SB1-07

SLICK Service Bulletin

SUBJECT: Inspection of magneto driver P/N K5265 and clarification of torque requirements.

Figure One

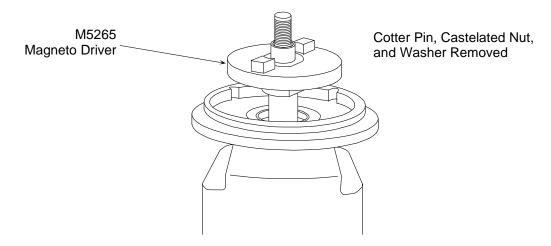
INSTRUCTIONS: 1. Remove cotter pin, castellated nut, washer, and M5265 magneto driver from magneto and hub (see Figure One). This driver may require the use of a puller for removal.

Figure Two

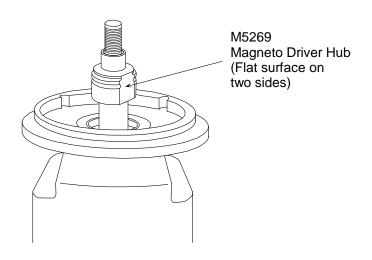
2. Visually inspect the M5269 magneto driver hub for any signs of cracking on the flat surfaces. See Figure Two.

Figure Three

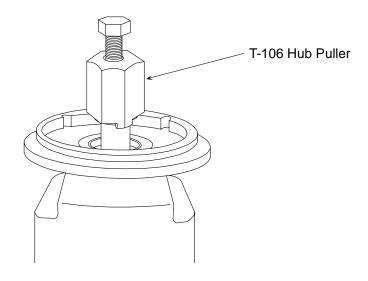
3. If any signs of cracking are present, remove the M5269 hub from the magneto shaft using only the Unison T106 hub puller as shown in Figure 3. Replace entire assembly using K5265 magneto driver kit.

- 4. Re-install magneto driver on magneto shaft.
- 5. Install washer M-5372 and nut M-3019. Torque castellated nut to 120 in. lb. (138†kg.†cm.), (13.5 mm) minimum.
- 6. If necessary, tighten nut further to align nut slot with cotter pin hole in shaft. Do not exceed 180 in. lb. (207 kg. cm), (20.3 nm).
